A Peer Review of the Strategy for Characterizing Transuranics and Technetium Contamination in Depleted Uranium Hexafluoride Tails Cylinders

G.P. Brumburgh, Project LeadLawrence Livermore National Laboratory

Executive Summary

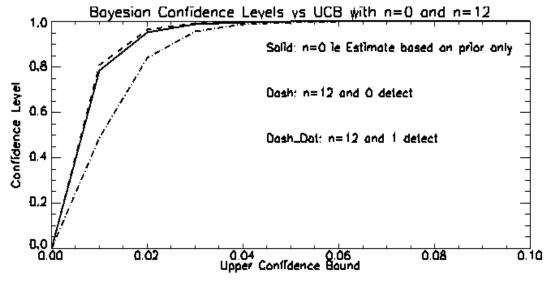
In regards to Pages 5–7 (Tables 1–3) and Appendix C [Hightower 2000]:

A significant amount of quantitative information is available based on prior analysis of cylinder data as evidenced in Table 1–3 and Table C1. Others have been alluded to in the proposal. Not using this information explicitly when possible restricts us to extremely conservative conclusion, leading to cruder confidence levels and larger sample requirements. These, in turn, lead to higher costs. The appropriate tool to use the prior information is provided in Bayesian statistics. Here, the prior information regarding the parameter to be estimated is captured in an appropriate prior distribution, and when new observations come in, they are used to update the prior distribution to one called the posterior distribution, from which confidence intervals for the parameters under investigation can be computed. As an example, suppose it is estimated that $\pi =$ Prob (a contaminant concentration exceeds the detection level). Based on the data in Table C1, an appropriate prior for π may be chosen as beta (0.993, 151). Suppose now, in a sample of size 12, no cylinder is detected with a contaminant concentration exceeding the detection level. The updated distribution for π is a beta (0.993, 163). If instead, one cylinder in the sample had a contaminant concentration exceeding the detection level, then the corresponding posterior distribution for π will be beta (1.993, 162). The prior and the two posteriors are shown in the figure below.

Notice that the confidence parameters are significantly improved with the same sample size as recommended in the proposal. Some confidence parameter pairs that can be read approximately from the figure are (85, 1) and (99, 2) for no "detect" and (85, 2) and (99, 3) for one "detect."
